**2 Type of change**

Modification of approval marks.

Product Change Notification					FIO marking		
owner	creation date	release date	released by	change order no	rev	page	D10-001-931
dislercy	2016-02-26	2016-03-04	bergerra	2009318	A	1 of 2

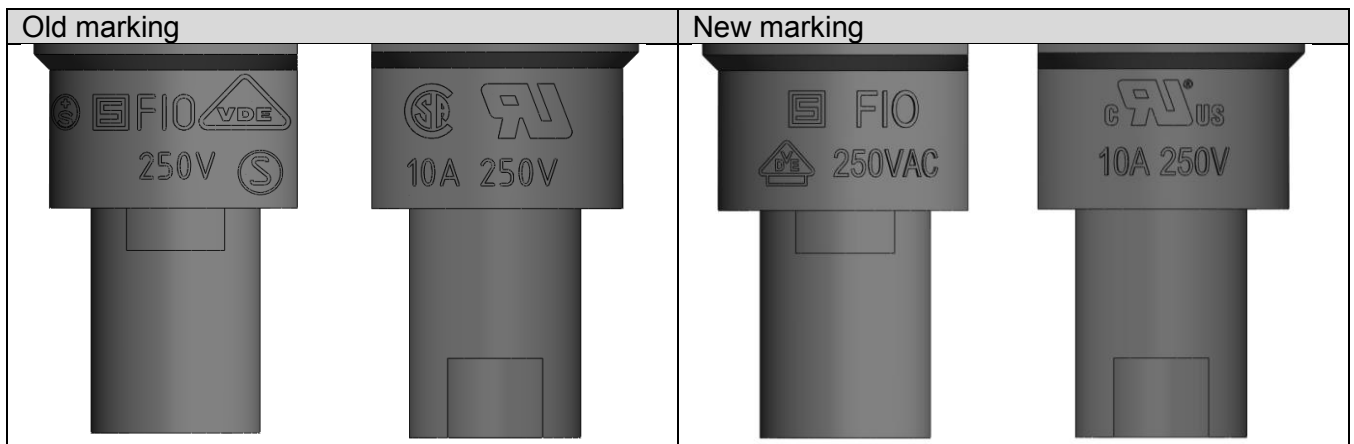
Old marking	New marking
UR	cURus
CSA	250VAC
250V	
Semko	
SEV	VDE
VDE ÜG	
10A 250V	10A 250V

Product Label	Yes	CSA and UR replace by cURus mark SEMKO and SEV marks replaced by VDE Add of electrical ratings
Customer Actions	No	Notification only
